David Wilson Homes

Response to WBC Highways

SLR Project No.: 184395

24 November 2025

PROJECT: Ducks Nest, Wokingham		CLIENT: David Wilson Homes (Southern	
DRAWING TITLE: PROPOSED SANG CAR PARK & ACCESS ROAD GENERAL ARRANGEMENT			
DRAWN: SCJ	CHECKED: SCJ	DATE: 20.11.25	SCALES: 1:500 @ A3
DRAWING NUMBER: 184395_PD14		REVISION: -

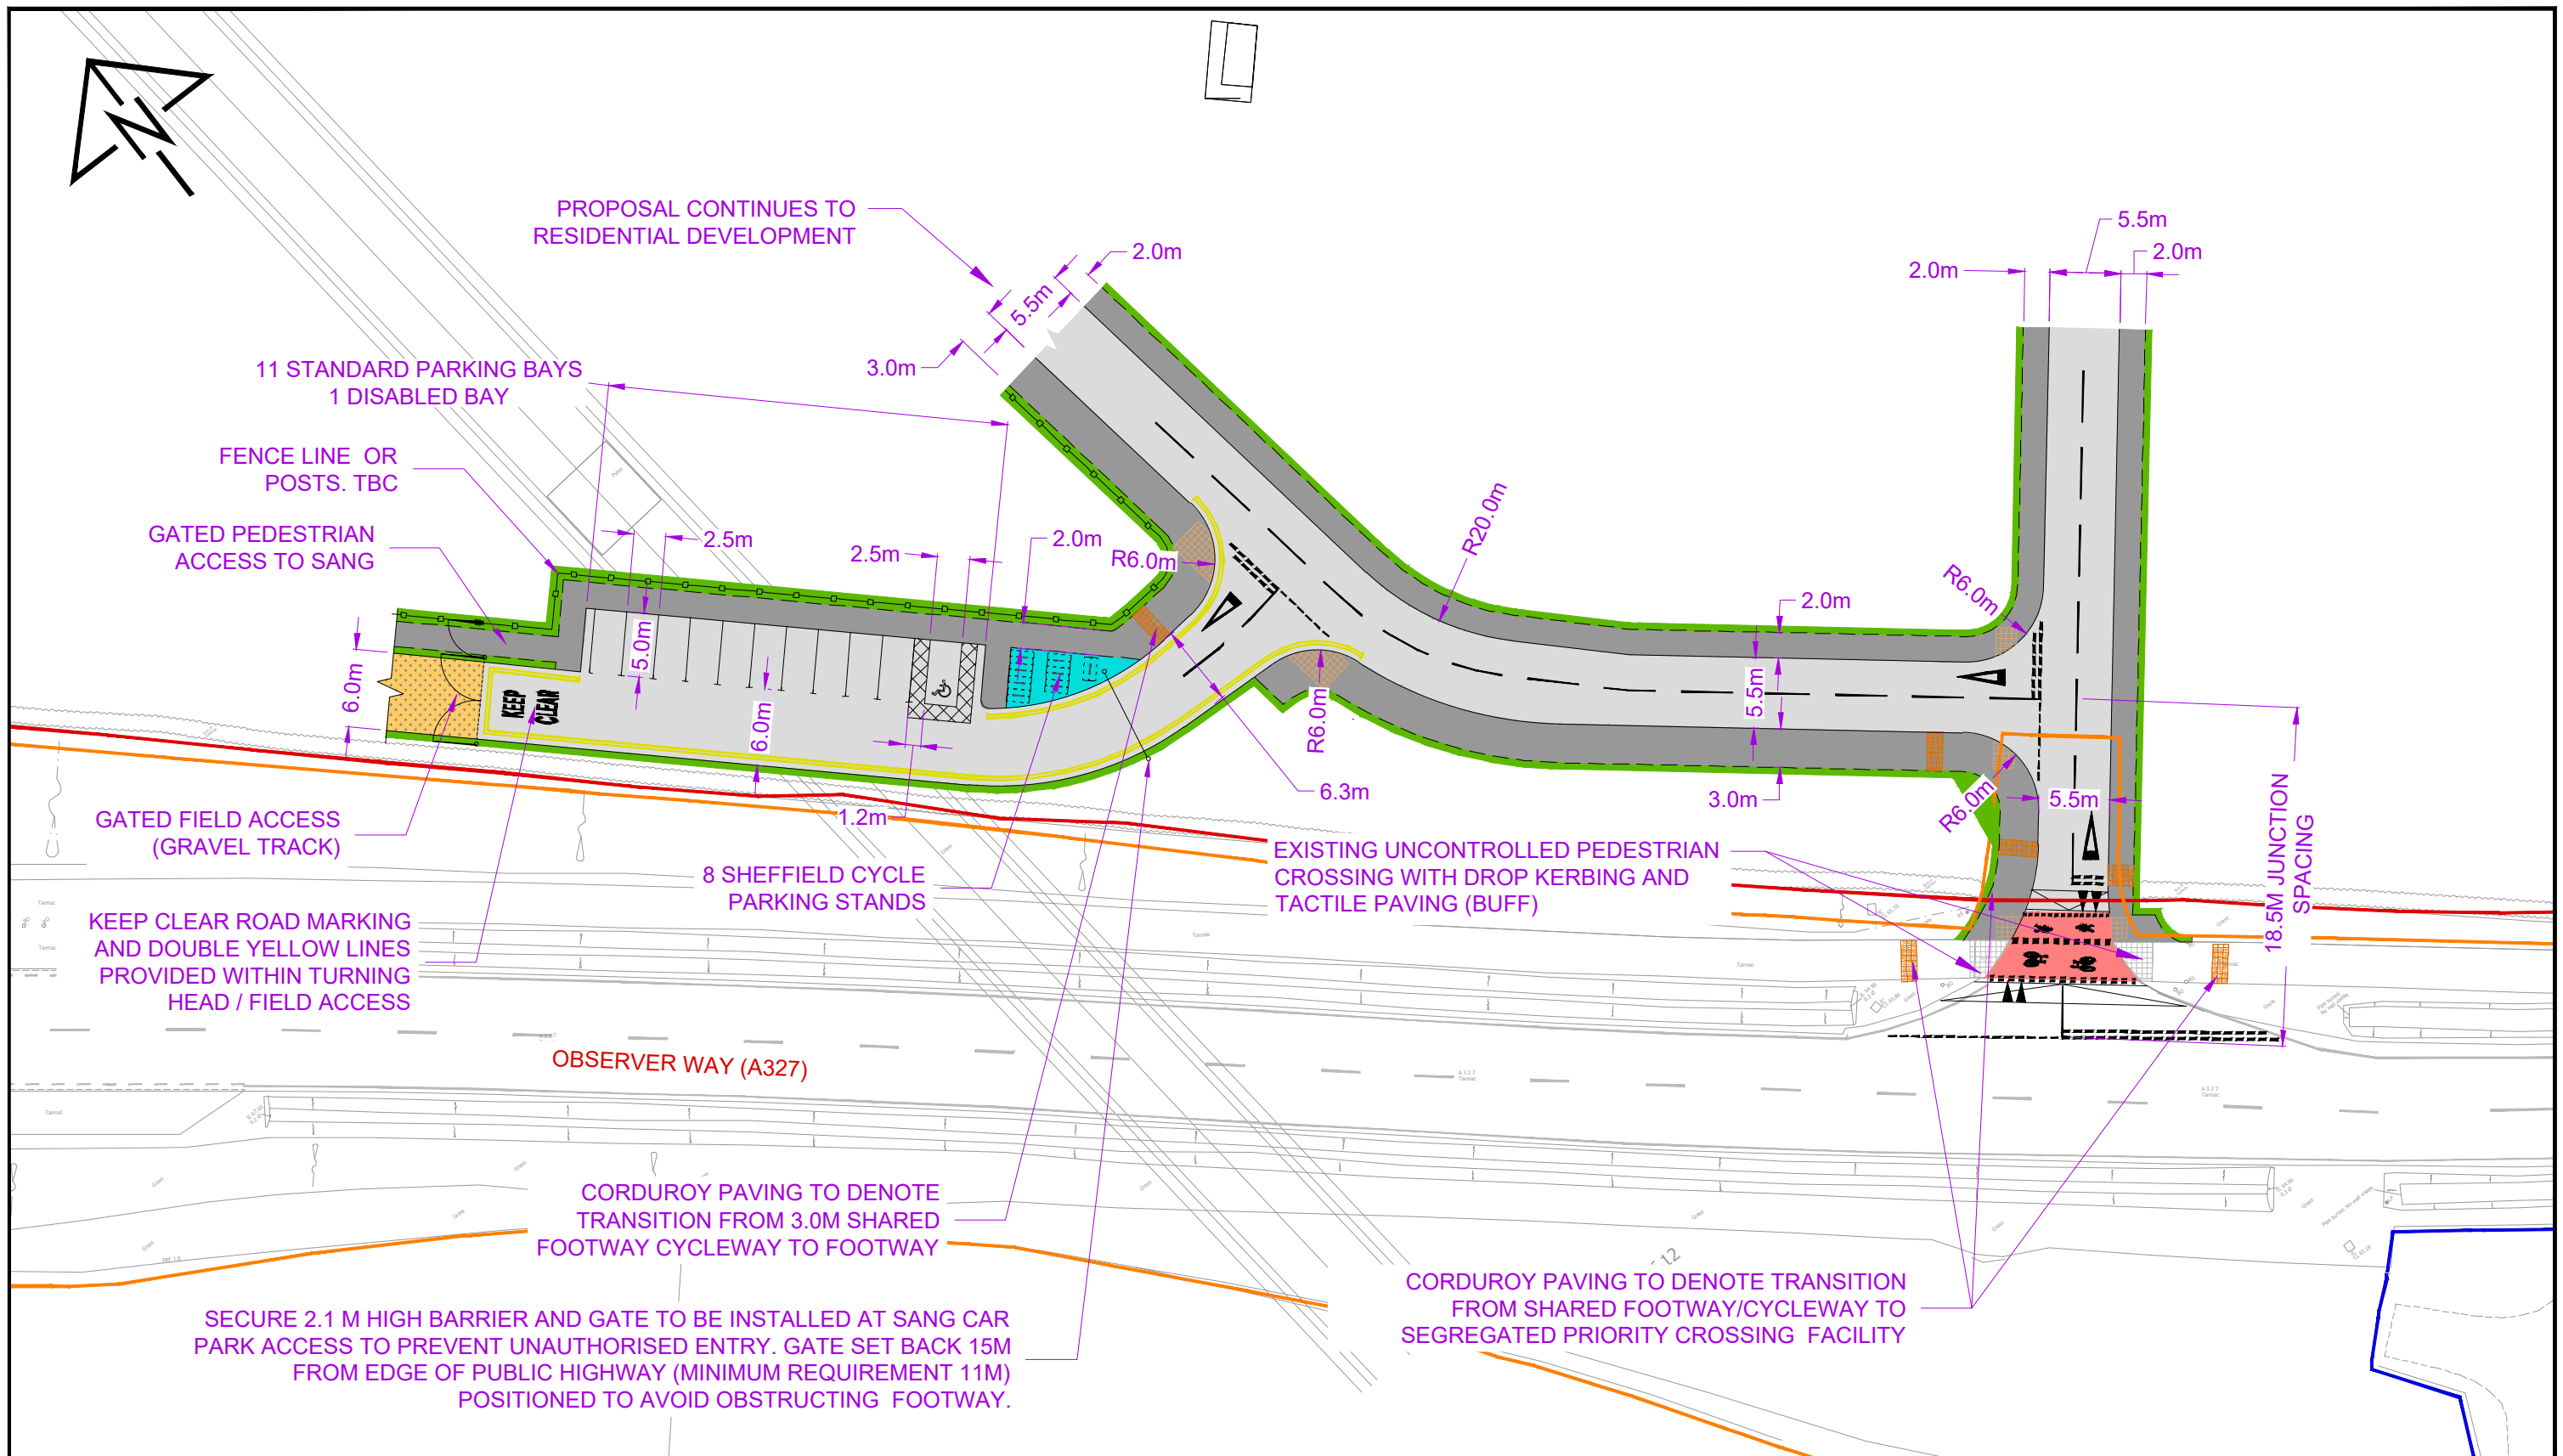
52. The comments at paragraph 52 with regard to signage positioning are noted and accepted.
53. The requirements for a height restriction barrier and gate to the SANG car park as per paragraphs 53 and 54 are noted and a plan showing the arrangement is included at **Appendix B**.

80. Paragraphs 80 and 81 relate to the SANG access and parking arrangements. The requests for additional swept path and amendments to the parking space dimensions are noted and included at **Appendix B**.
